Indian comments on major outstanding issues on **EPPR-12-05e**

6th Sept 2015

2. Family definition

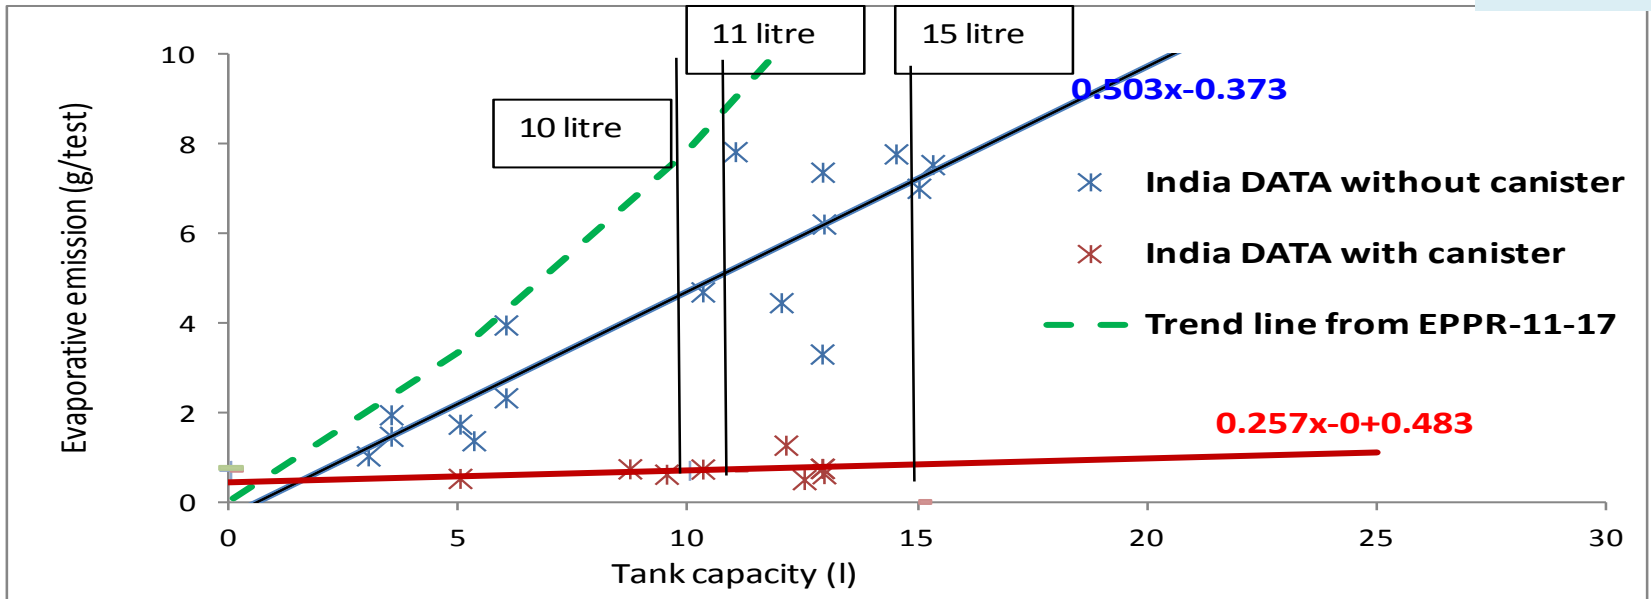
- India had proposed the family definition for fuel tank capacity to be +10%/-50%. (Item 2.2.6 of table 3.6.1 of EPPR 11-07)
- Japan had provided data that an increase in fuel tank capacity would affect the Evaporative emission considerably. (EPPR-11-07)
- However this study is based on evaporative emission from two wheelers without canister
- The following is the analysis using data generated in India:
 - With canister
 - Without canister
 - Test procedure as per CARB

Fuel tank volume

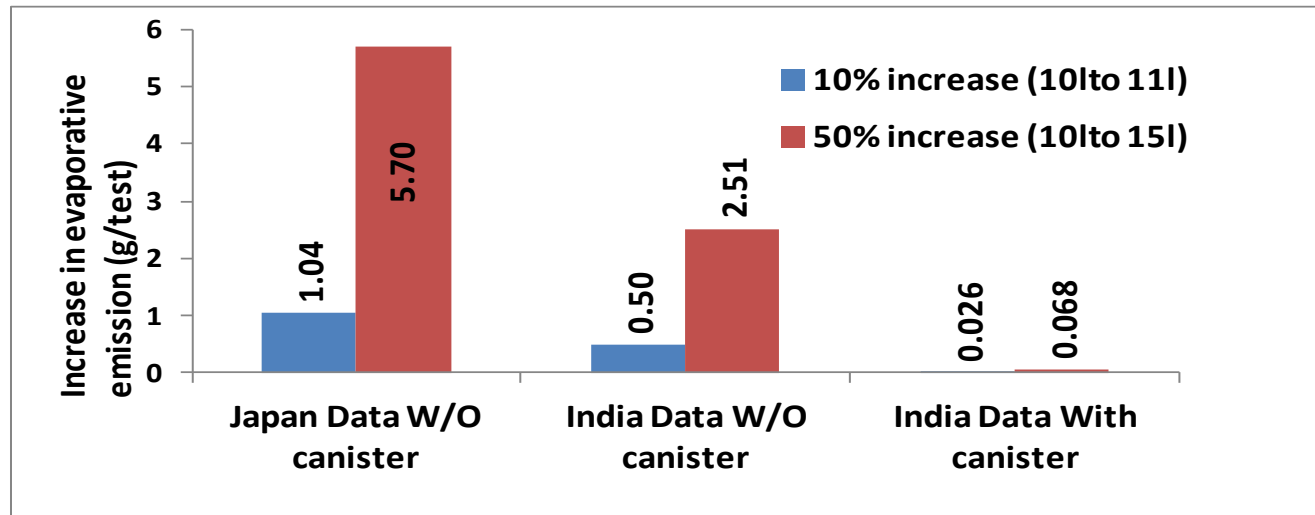
The increase in Evapo emission for increase in fuel tank capacity from 10 l to 11l (10% increase) and 10 l to 15l (50% increase) is shown below:

- Without Canister, the increase in the evaporative emission is significantly high in both Indian and Japanese data
- But, increase is marginal on the data with canister, at 10% increase of fuel tank capacity
- There is a possibility of a two wheeler say less than ~4l capacity, complying with evapo emission requirements without a canister.
 - In such cases +10% need not be permitted.

- India therefore proposes that
- *“the fuel storage capacity declared by the manufacturer is within a range of*
 - *+10 /- 50 % of the nominal volume, if fitted with an evaporative control system and*
 - *+0/-50% if **not** fitted with an evaporative control system.”*
